Re: 5923 Ottawa Street – Richmond, Ontario - Rail Safety / Proximity Review R2  
Rail Safety Consulting & Engineering Services  
Our Project No. EN024-01926

**Subject: Feedback Form – Completeness Review #1**  
**Site Plan Control**  
**5923 Ottawa Street**

Figure 2: Topographic Survey of 5923 Ottawa Street

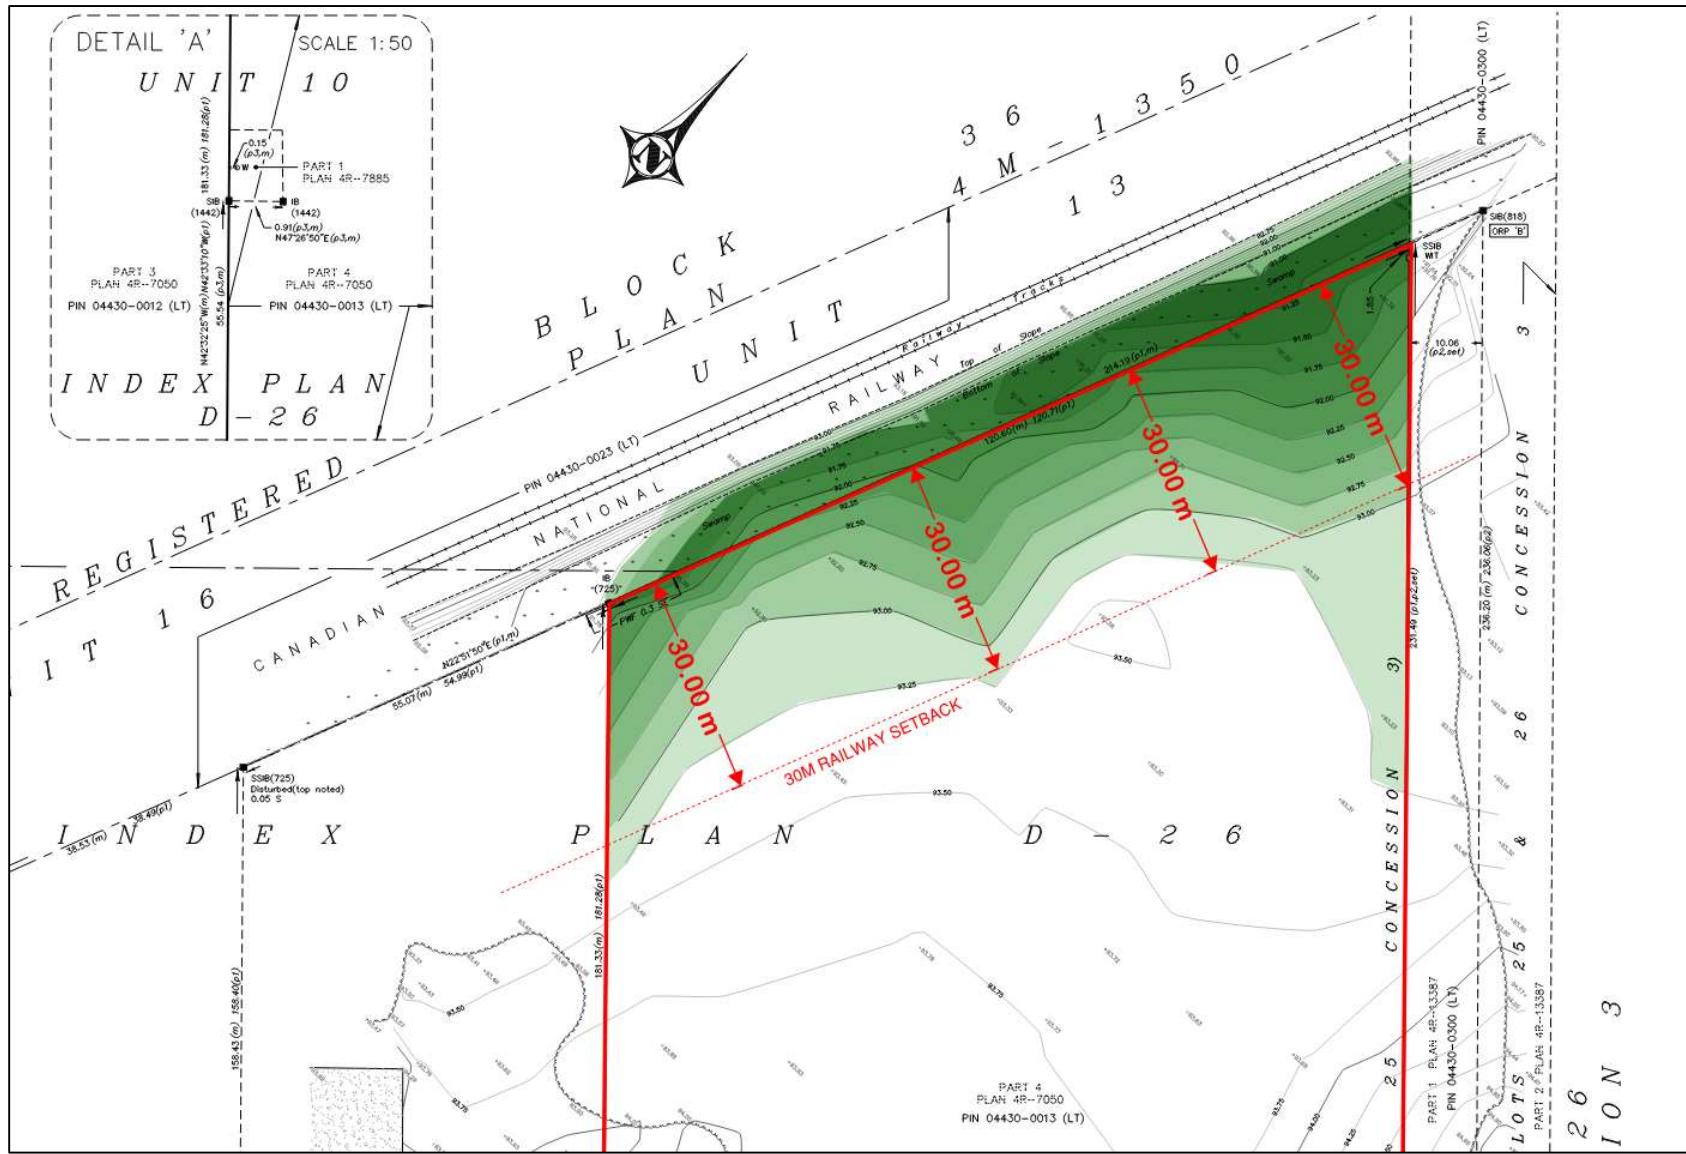
C20. The contours on Figure 2, of the Rail Safety/Proximity Review, are not legible.  
Refer to survey in Appendix.

C21. Figure 2, of the Rail Safety/Proximity Review does not show/state/educate on the ditch. The green suggests some sort of grade change, but not enumerate it nor convey that there is a ditch there (as opposed to a single-sided grade change).  
Text clearly summarizes ditch conditions and includes summary of elevations. Also indicates that it is not one-sided.

Figure 1: Snippets of the grading plan and aerial imagery showing approximate impact area of the proposed swale.

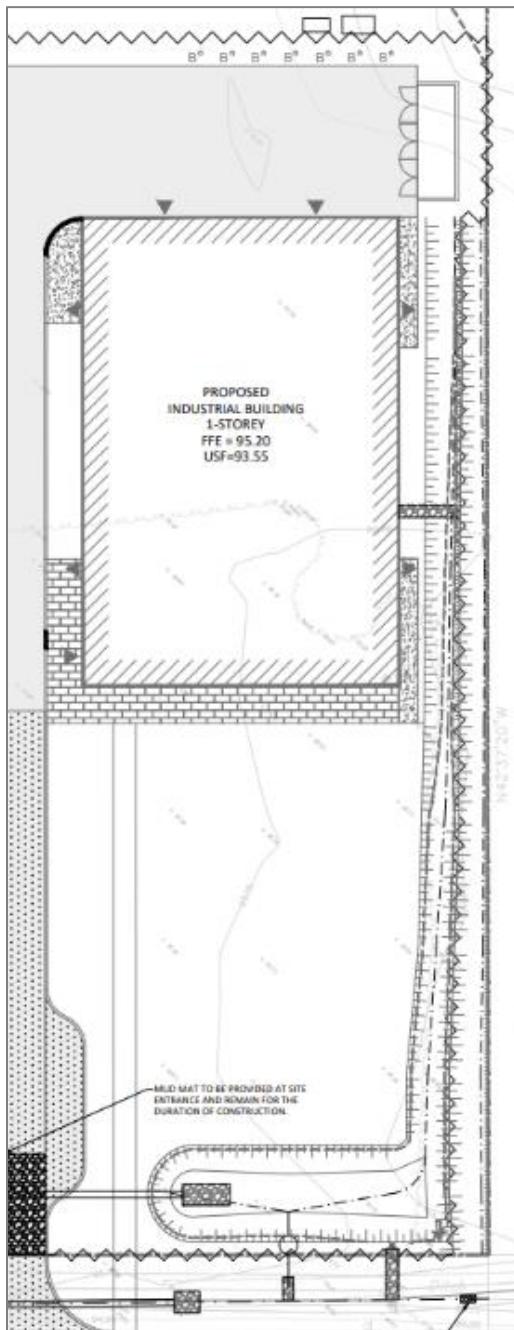
D31. The Erosion & Sediment Control, and Grading and Drainage Plans show a proposed swale along the eastern property line, which would impact the adjacent, City-owned trees. The swale should be designed to limit excavation within the critical root zones of those trees (see below Figure for approximate outline of impacted area).

Figure 2: Snippet from Landscape Plan showing possible conflict between bicycle parking and other users.

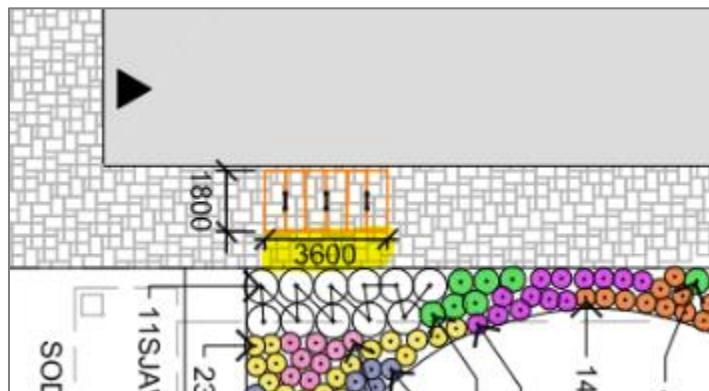
C74. Review bike rack location for Building #2. As per Zoning Bylaw, Section 111 (9) “*A bicycle parking space must have access from an aisle having a minimum width of 1.5 metres.*” This space, highlighted in yellow below, is also required to ensure accessible pedestrian access around the bike rack as per AODA standards.
